DAR topics

previous DAR comments | challenges

nw quimby street

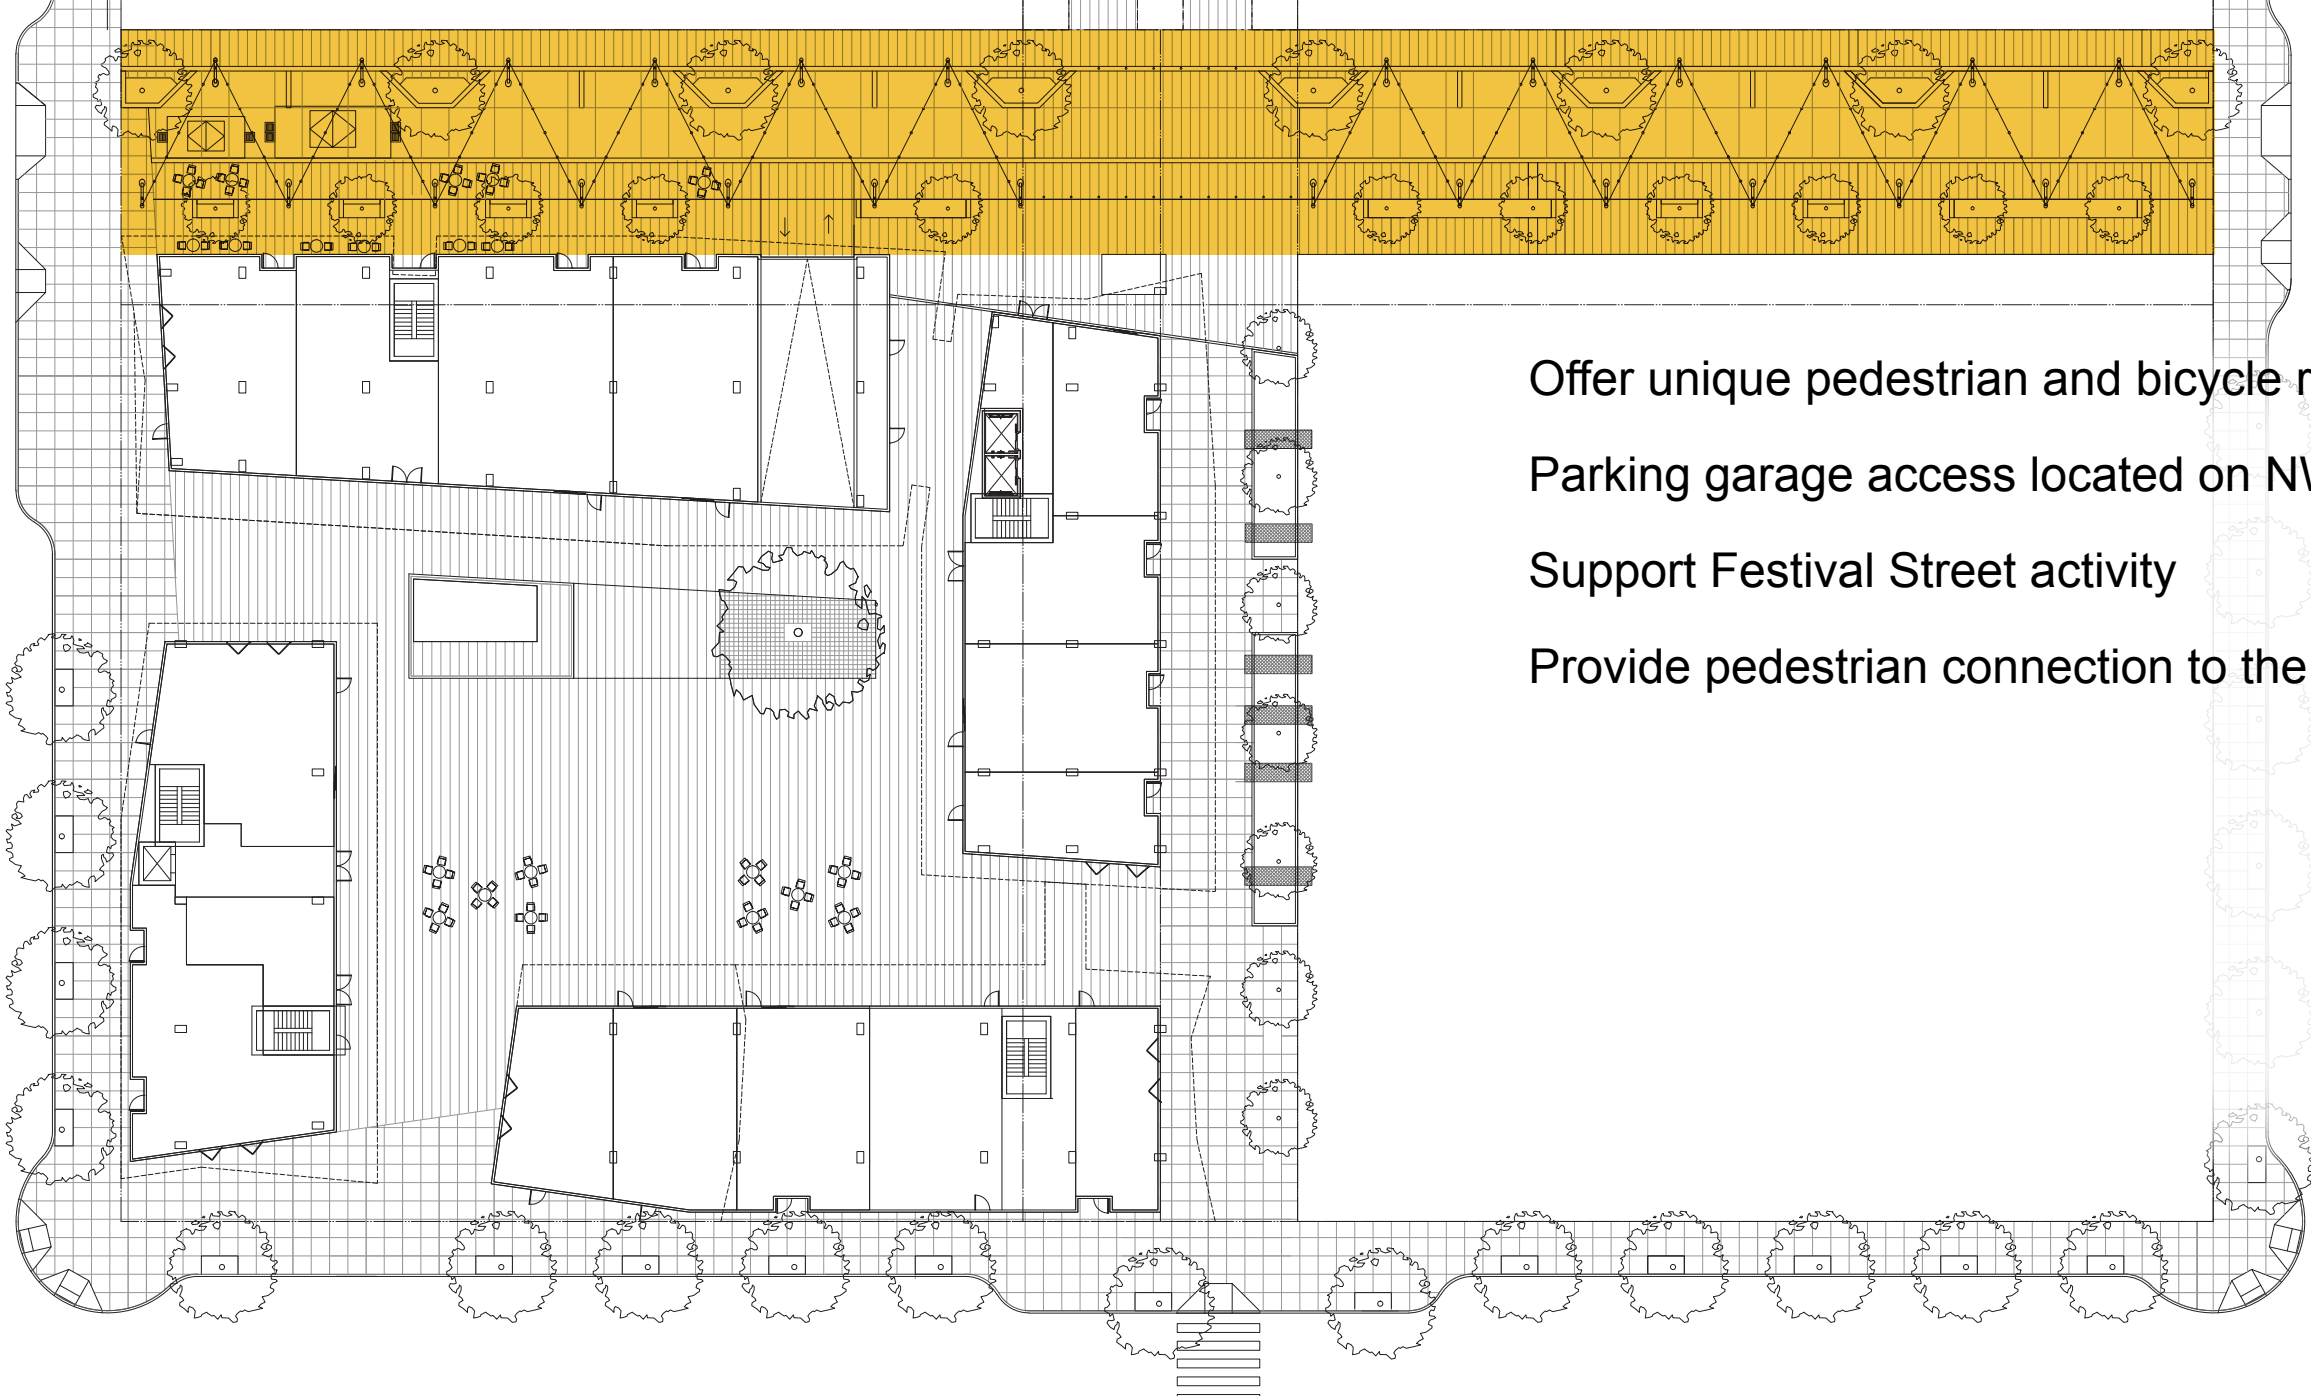
4. Quimby - Festival street for pedestrians and bicycles

- Offer unique pedestrian and bicycle realm
- Parking garage access located on NW Quimby
- Support Festival Street activity
- Provide pedestrian connection to the park and the square
